To:	Tim Cazier	From:	Paul Kos
	DRMS	Cc:	Jerald Schnabel, Riverbend
Project/File:	Pikeview Quarry Reclamation Project	Date:	November 17, 2023

Reference: Responses to Preliminary Adequacy Review for Technical Revision (TR-22), Pikeview Quarry, M-1977-211

On October 9, 2023, DRMS provided comments following their preliminary adequacy review of the TR. This memorandum summarizes the comments and Riverbend's and Stantec's responses to those comments. The revised hydrologic model reports have been included as attachments.

Major Channels

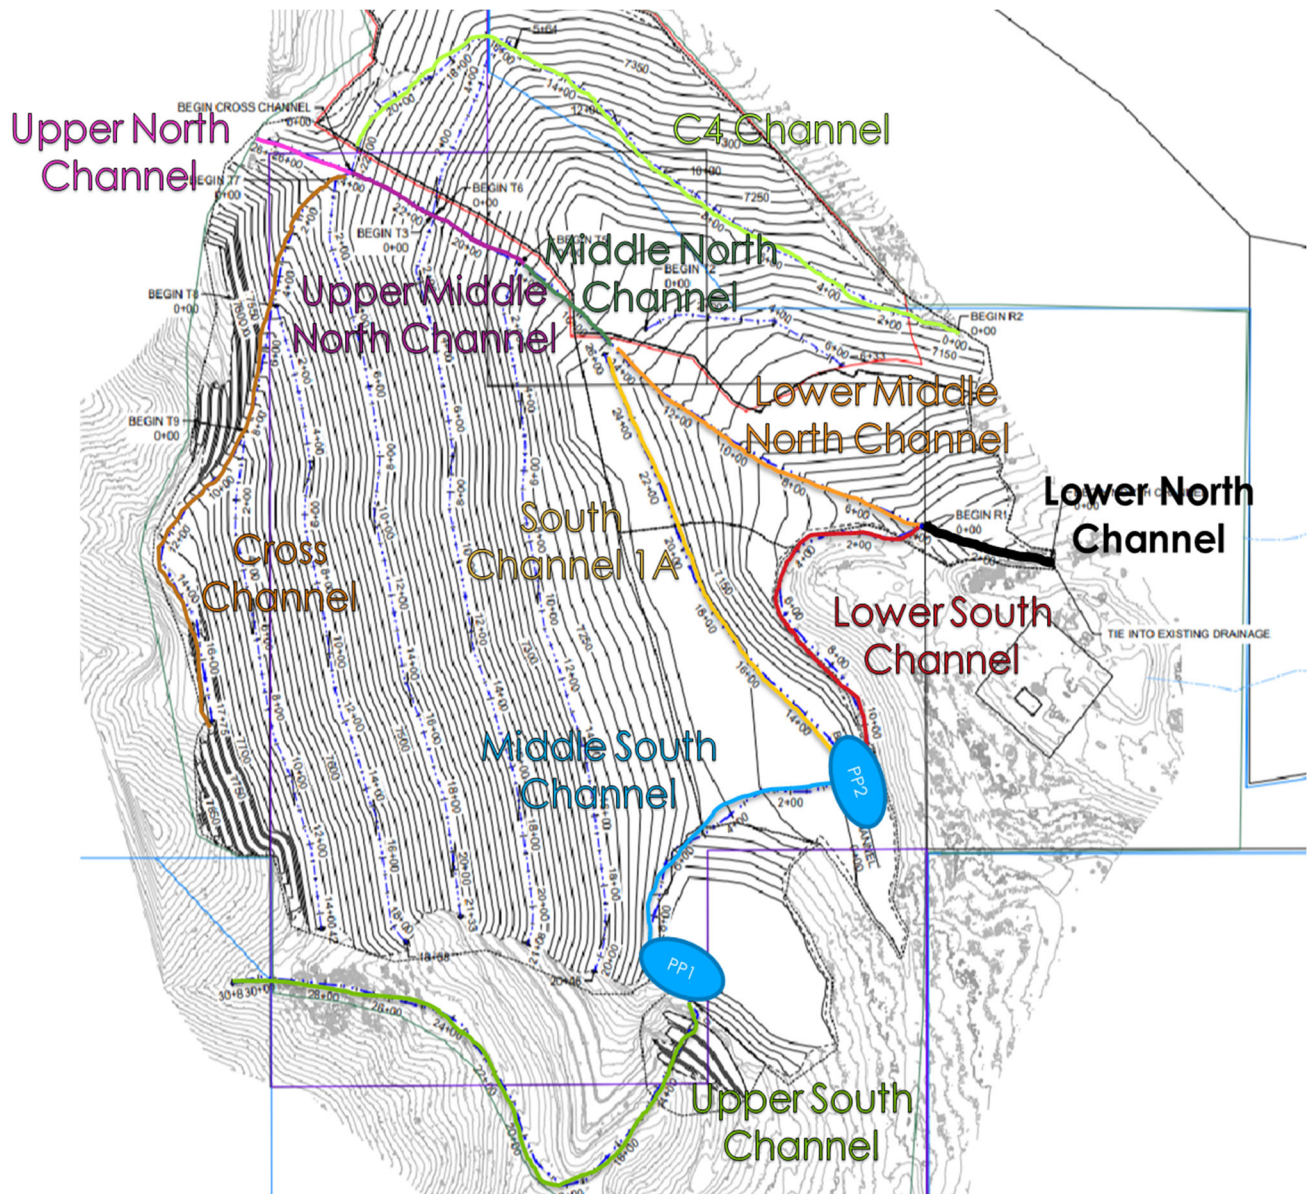
Comment 2. North Channel: The DRMS believes the Middle North Channel, Lower Middle North Channel and Lower North Channel may be undersized.

Comment 3. Terrace Channels: Please provide rationale for how the terrace channel design flow was obtained and revise if appropriate. Also, revise the design or explain why a terrace channel was not included north side of the North Channel at Sta. 18+00.

Response: The HEC-HMS model has been updated to clearly show the watersheds and drainage network. See attached model reports and flow summary table. The updated model reports are attached to this response.

- **Lower North Channel:** The downstream connection was changed from F2 to J-F2 which was an added junction before J-Out. J-F2 was used to size the Lower North Channel.

- **Lower Middle North Channel:** Assuming the last “F3” mentioned in the comment is supposed to be referring to F1, the downstream connection for F-1 was changed to J-F1-1, which was an added junction before J-F1. J-F1-1 was used to size the Lower Middle North Channel. The change in flow caused the riprap size to increase from 12-in to 18-in d50.
- **Middle North Channel:** No changes were made to the downstream connection of Subbasin C3 because the basin is graded such that it drains to the new minor channel at station 12+00 and then is routed directly to the point J-C2.

Response: The HEC-HMS model has been updated to clearly show the watersheds and drainage network. See attached model reports and flow summary table. The maximum flow from the minor channels is 39.3 cfs, so 40 cfs was used as the design flow for the minor channels. A terrace channel has been added on the north side of the channel at STA. 18+00. Runoff collects on the bench and is diverted to the North Channel. Another terrace channel was added on the north side of the North Channel, and this channel collects runoff from the lower bench and diverts it to the North Channel.

PROJECT
PIKEVIEW QUARRY RECLAMATION PROJECT
TYPICAL CHANNEL DETAILS

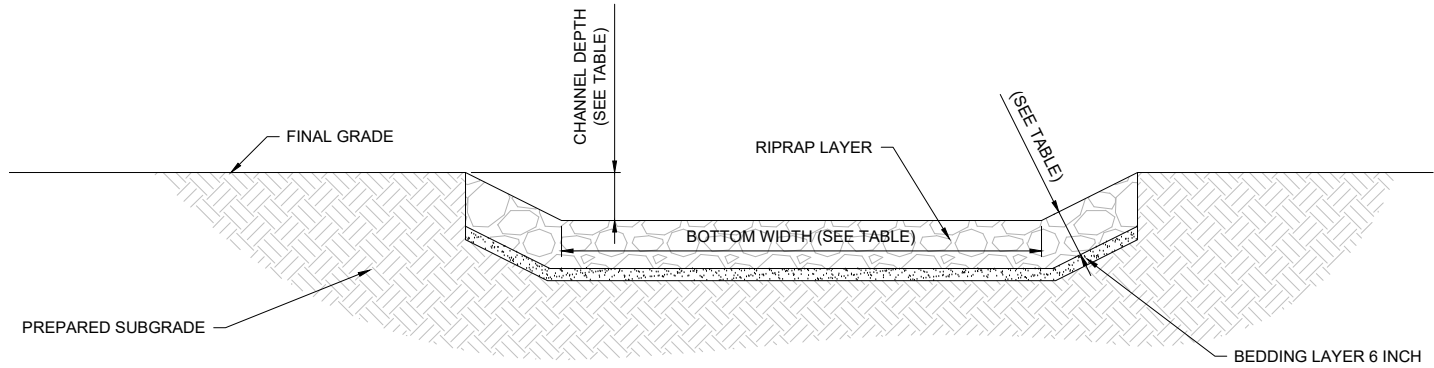
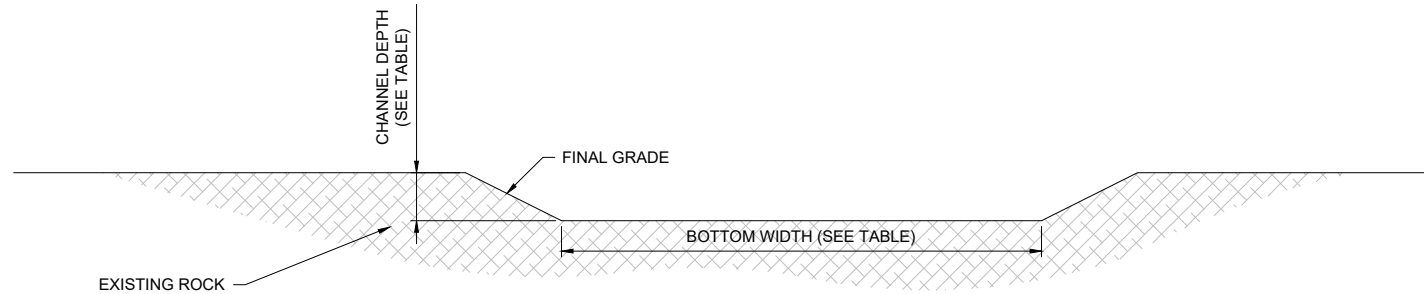
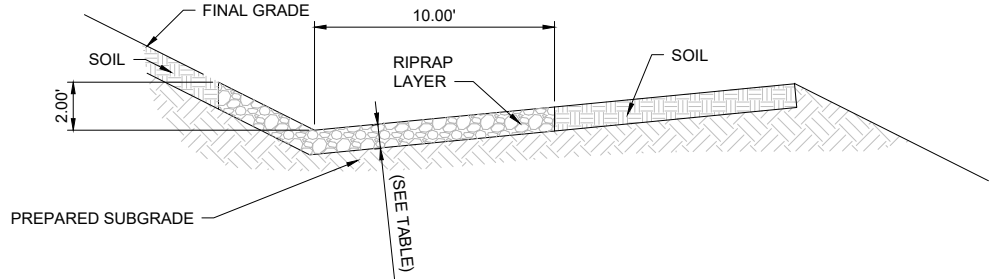
Comment 4. Upper South Channel, Riprap Quarry: Provide rationale for how the two-foot channel depth was determined and provide some discussion as to why plunge pools to dissipate the energy on each of the flat receiving benches were not included.

Response: The Upper South Channel was assessed using the minimum channel slope as freeboard is the governing design parameter (because no riprap will be placed on the bedrock channel). The table has been updated to show the minimum channel slope. Channel maximum slope remains “not applicable” because the channel will be excavated into bedrock rather than riprap lined, and thus does not require a calculation to determine riprap size.
